**MODEL SLOPE/DATUM**

**From:** Gaines, Roger A MVM  
**Sent:** Saturday, August 24, 2002 12:54 PM  
**Subject:** Pokrefke, Thomas J ERDC-CHL-MS  
model supplementary slope and datum

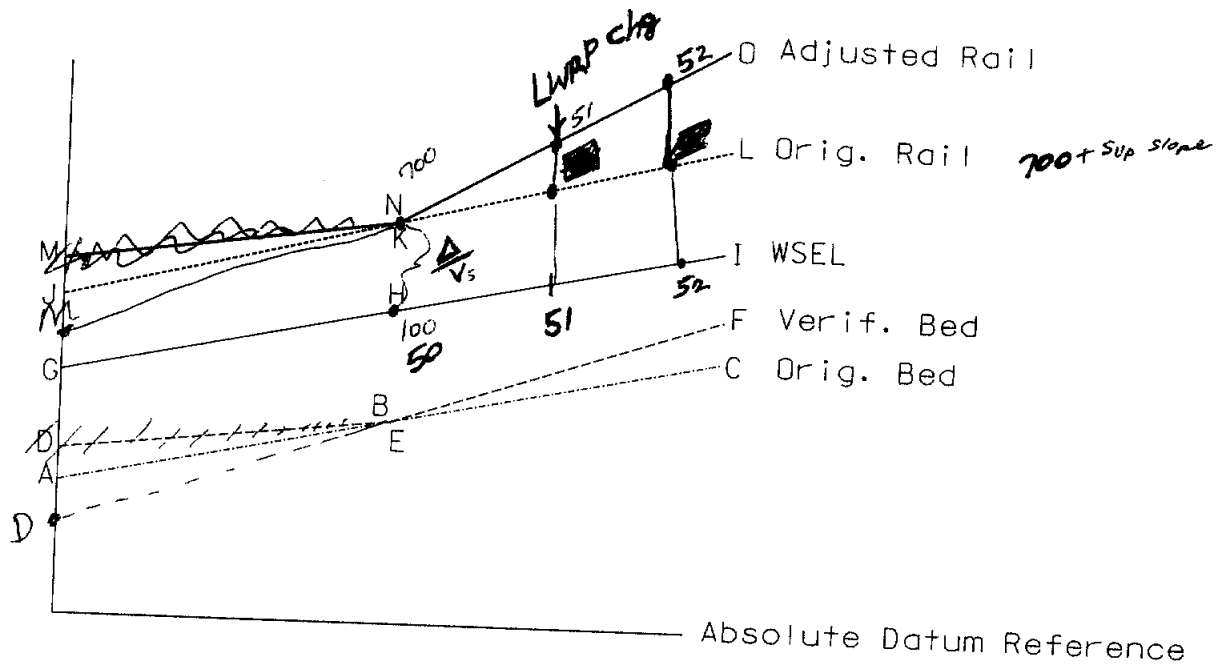
ABC = Original Bed Position

DEF = Adjusted Bed (Verification effort)

GHI = WSEL for a given discharge -- does not change for rail adjustments

JKL = Original Rail position

MNO = Adjusted Rail Position

Initially, sediment movement between JK is too high and between KL is too low. Therefore, raise the rail position at O to increase velocity in upper part of model to increase bed slope; also raise the rail position in lower part of model to decrease velocity by decreasing bed slope.

This works because the WSEL remains "constant." Question: How can the WSEL remain a constant LWRP elevation (relative to the rail) if the rail position changes? I can see the absolute elevation (based on the absolute datum shown at the bottom) of the WSEL remaining constant provided the rail adjustment is not too great, but not if the rail defines the datum. If the rail is the datum, then the WSEL must also change. If only the mid-point is used to define the WSEL, then is any of the above true (does the WSEL remain unchanged)? Ultimately, what slope is used in the model?
